STAFF RECOMMENDATION 108 Rosebank Avenue April 17, 2019

Application: New Construction—Addition; Partial Demolition
District: Eastwood Neighborhood Conservation Zoning Overlay
Council District: 06
Base Zoning: R6
Map and Parcel Number: 08303018400
Applicant: Cheyenne Smith
Project Lead: Melissa Baldock, melissa.baldock@nashville.gov

Description of Project: Application is to remove a non-contributing part of historic house and construct rear addition with a ridge raise.

Figure 1. 108 Rosebank

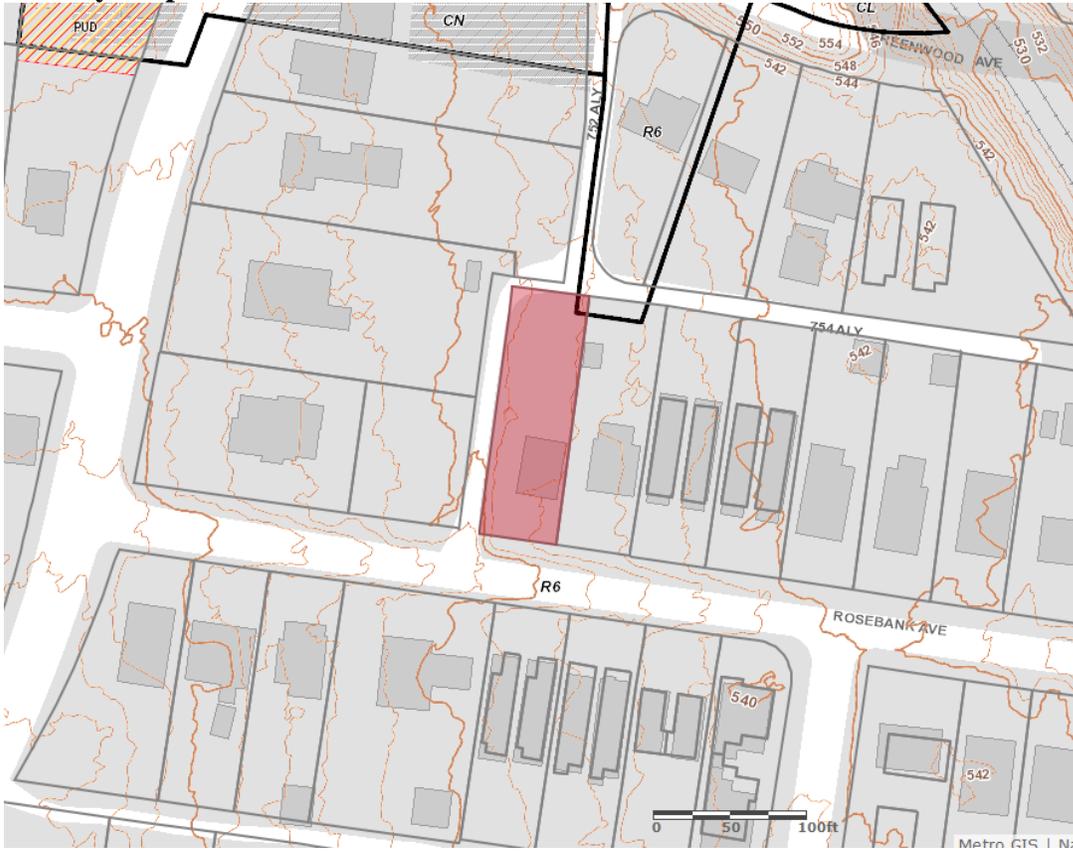
Background: 108 Rosebank is a c. 1925 frame cottage that contributes to the historic character of the Eastwood Neighborhood Conservation Zoning Overlay (Figure 1).

Figure 2 (left) shows the rear extension to be removed. Figure 3 (right) is the 1957 Sanborn map which shows this bay as a covered porch.

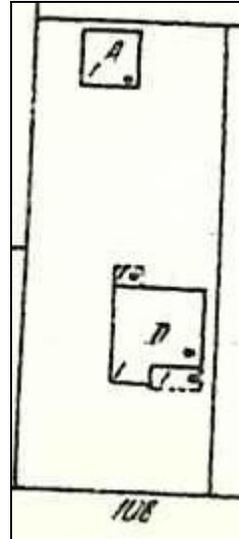
Partial Demolition: The applicant intends to remove a small rear extension to the historic house and to alter window openings on the right side façade, both of which are considered partial demolition. At the rear, the applicant intends to remove a rear bay extension (Figure 2). The 1957 Sanborn map shows that this bay was formerly a covered porch (Figure 3). Although likely original to the house, covered porches like this one were often not constructed to last near a century. Because they are often not structurally sound, they are typically not highly visible from the street, they are not architecturally distinguished in terms of roof form and materials, and they have typically been altered to be fully enclosed, the Commission has regularly approved their removal. Staff therefore finds that the removal of the rear bay extension to be appropriate.

SITE PLAN AND
DEMOLITION PLAN

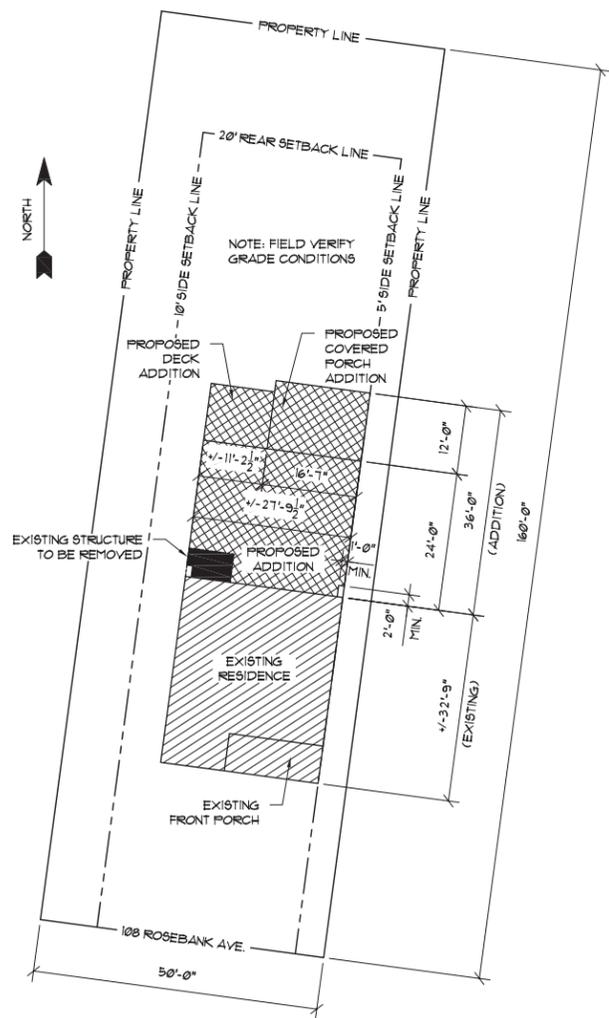
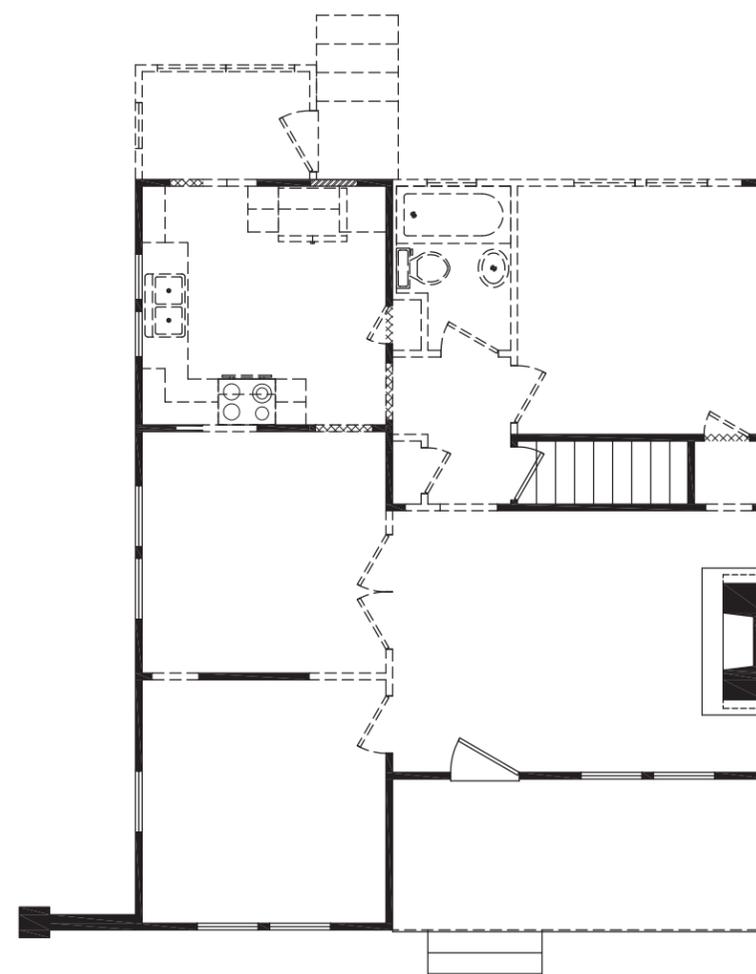
Setback & Rhythm of Spacing: The addition meets all base zoning setbacks. It is five feet (5') from the right side property line, approximately seventeen feet (17') from the side property line, and over sixty feet (60') from the rear property line. Since the addition is no wider than the historic house, it will not alter the rhythm of spacing of houses on this street.

EXTERIOR
ELEVATIONS

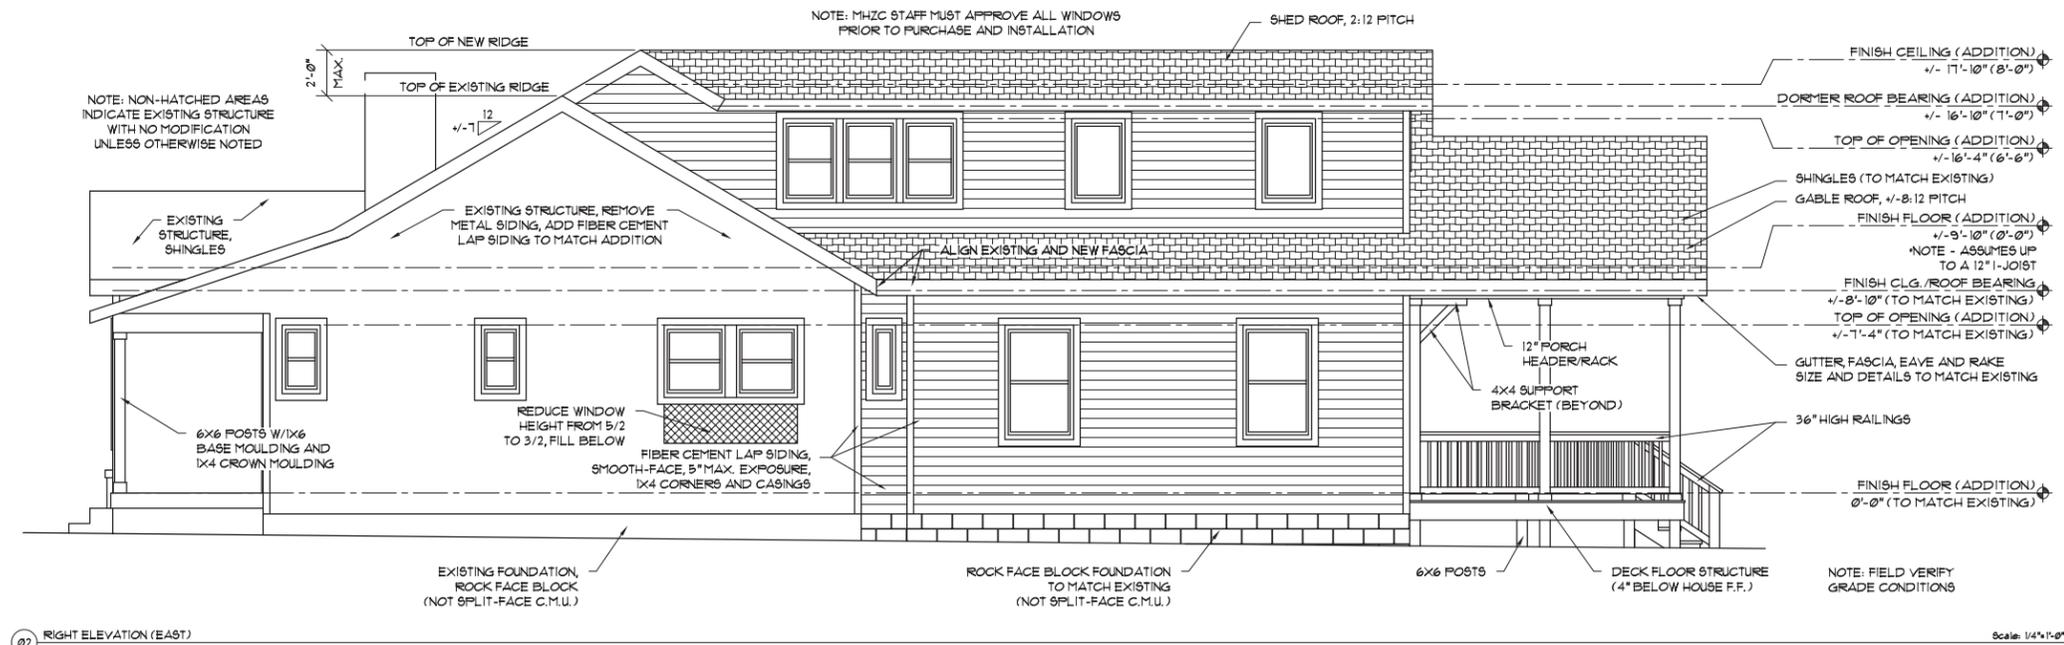
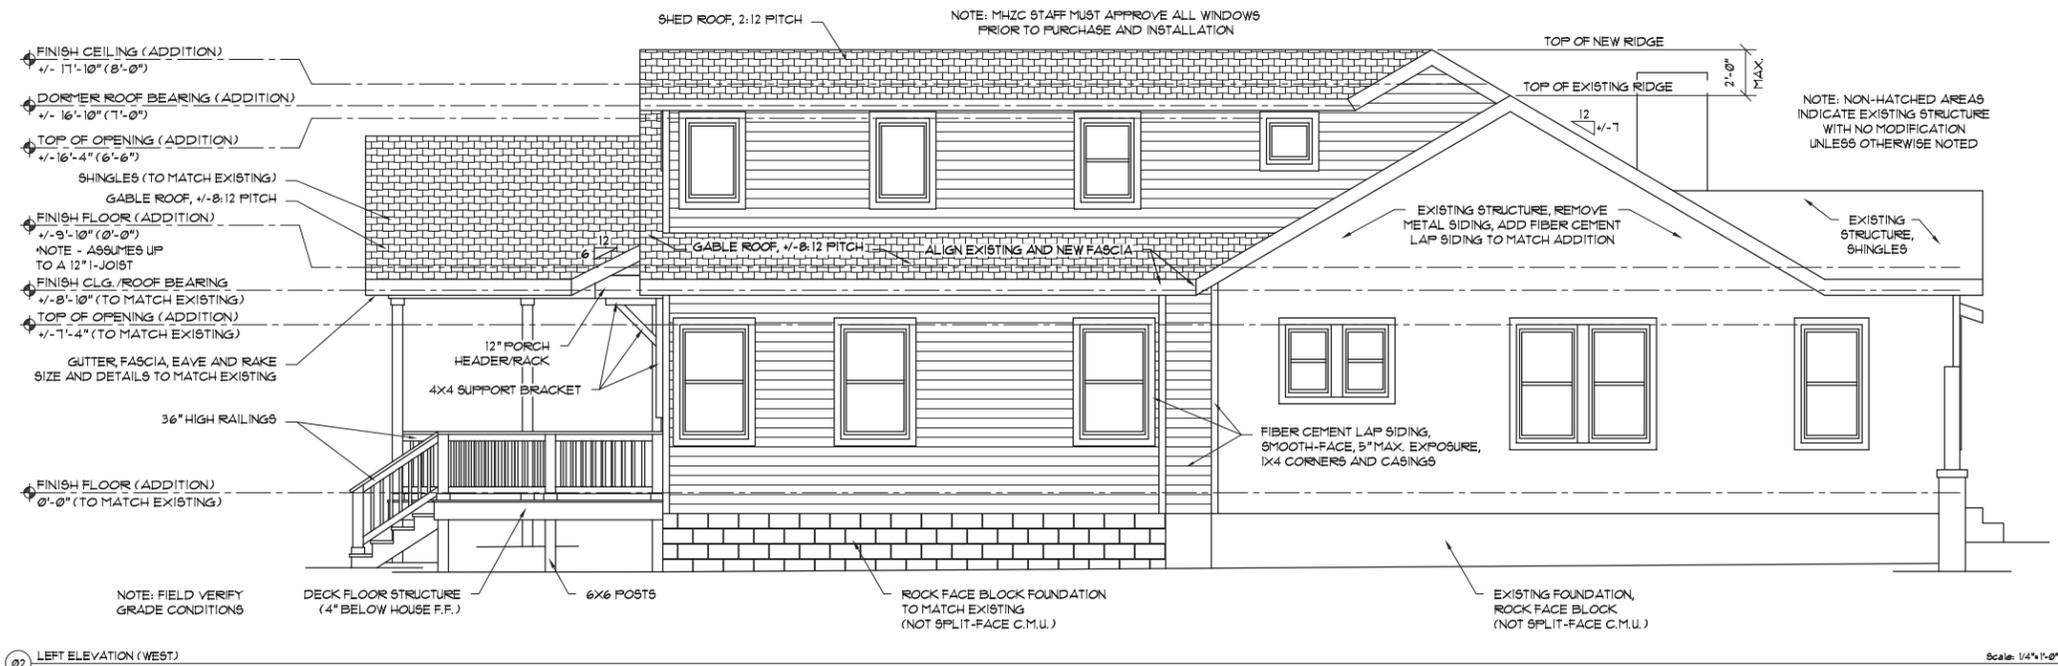
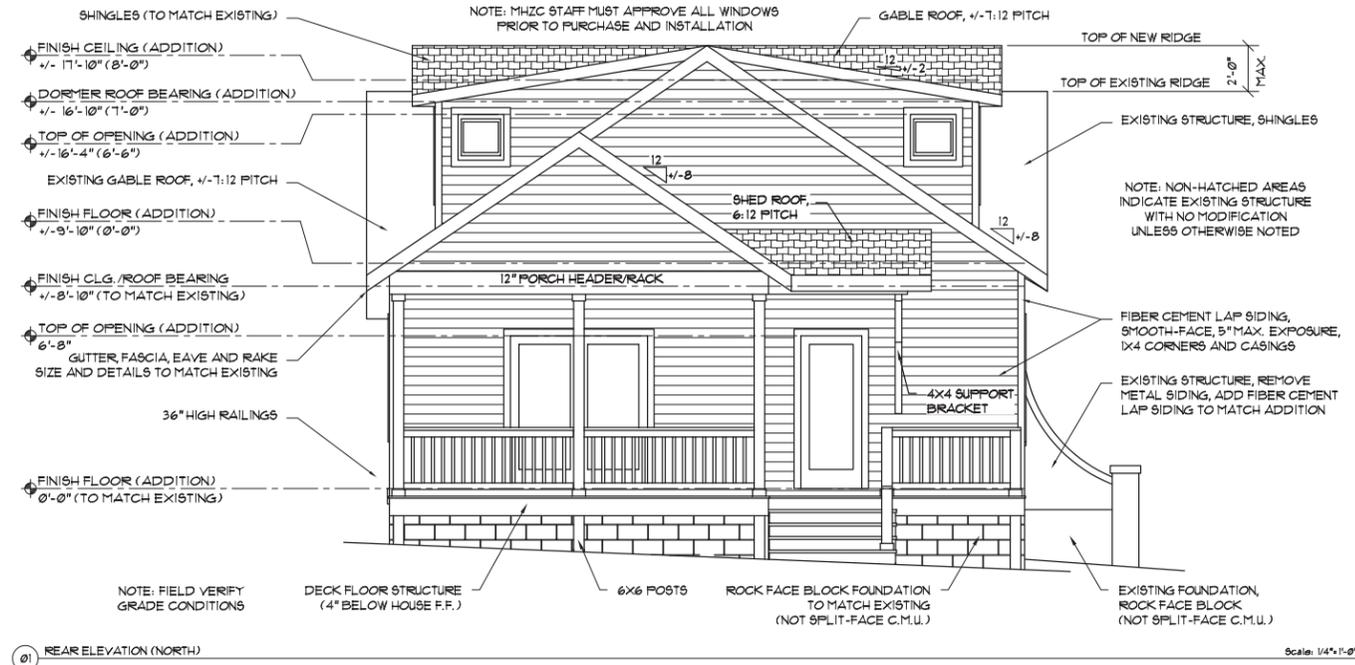
Height & Scale: The addition involves a ridge raise. The roof's ridge will be raised two feet (2'), but will be stepped in two feet (2') on each side so that the original roof line can still be discerned. The ridge raise meets the stipulations put forth in the design guidelines. The addition will therefore be two feet (2') taller than the historic house, which meets the design guidelines. It will be one-and-a-half stories in height.

The addition will step in one foot (1') at each of the back corners of the house, which is appropriate. After a depth of two feet (2'), the addition steps back out to match the height of the house on the first floor. The second floor dormers will be inset two feet (2'), which is appropriate. The addition will add approximately nine hundred and fifty-seven square feet (957 sq. ft.) to the historic house, which is currently approximately one thousand and twenty-six square feet (1,026 sq. ft.).

Roof form: As described under “Height and Scale,” the application involves a two foot (2’) ridge raise that is inset two feet (2’) on each side. The main roof form of the addition is a gable with an 8/12 pitch. The second story dormers are have 2/12 shed forms; these dormers are inset two feet (2’) from the main wall of the historic house, which is appropriate.

Proportion and Rhythm of Openings: The change to the historic window opening on the right façade was discussed under “Partial Demolition.” The windows on the proposed addition are all generally twice as tall as they are wide, thereby meeting the historic proportions of openings. There are no large expanses of wall space without a window or door opening.

1. Staff approve all windows and doors and the roof shingle color prior to purchase and installation; and,
2. The HVAC be located behind the house or on either side, beyond the mid-point of the house.
